FLORIDA POWER AND LIGHT COMPANY

TURKEY POINT PLANT UNIT NO. 3

Amendment No. 56
License No. DPR-31

SAFETY EVALUATION BY THE OFFICE OF NUCLEAR REACTOR REGULATION
RELATED TO AMENDMENT NO. 56 TO FACILITY OPERATING LICENSE NO. DPR-31
AND AMENDMENT NO. 48 TO FACILITY OPERATING LICENSE NO. DPR-41

FIGURE 3.1-1c TURKEY POINT UNIT 3 REACTOR COOLANT HEATUP LIMITATIONS APPLICABLE FOR PERIODS FROM 5 TO 10 EFFECTIVE FULL POWER YEARS.

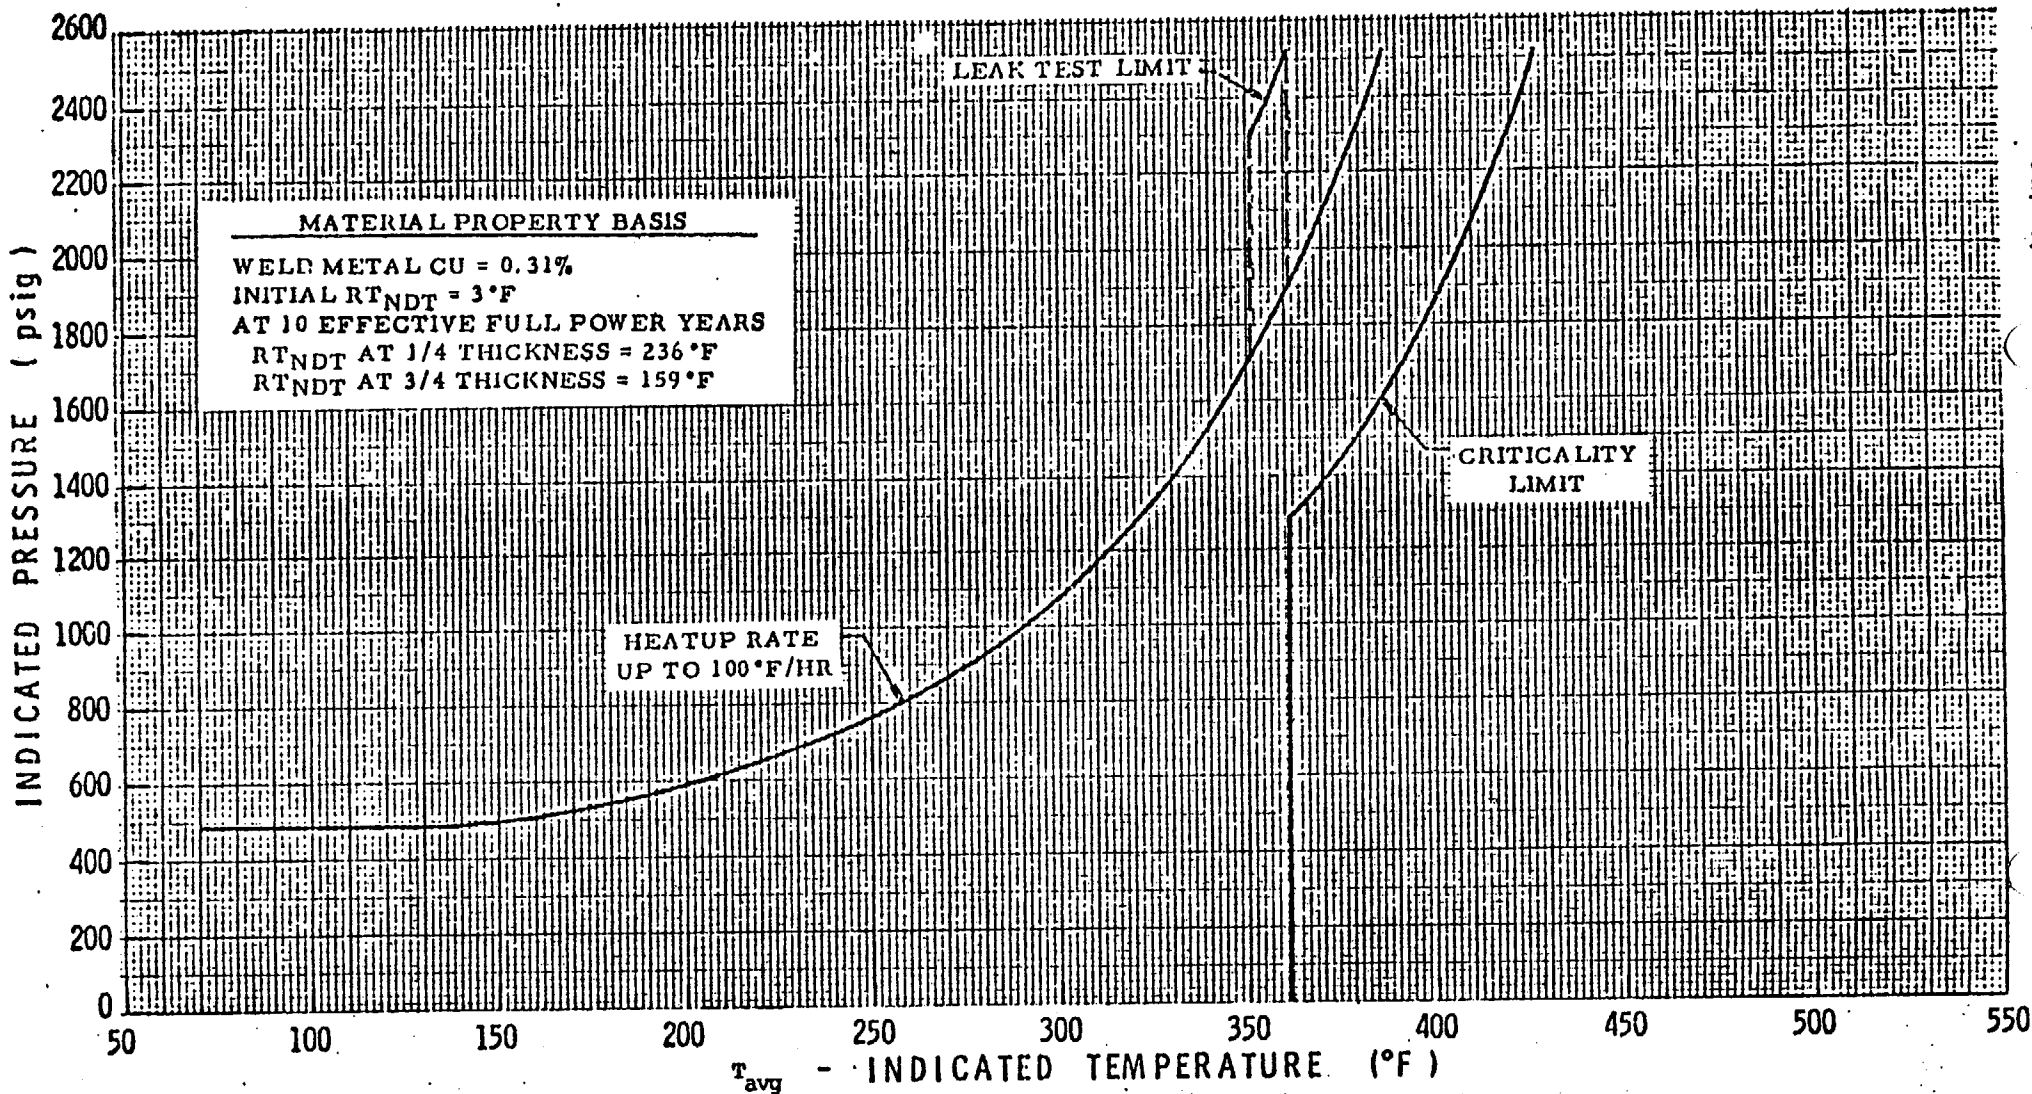
These amendments revise the reactor coolant pressure-temperature limits to account for neutron irradiation induced increases in reactor vessel metal ductility temperature.

Revise Appendix A as follows:

Figure 3.1-1c
Figure 3.1-2c
Figure 3.1-1d
Figure 3.1-2d
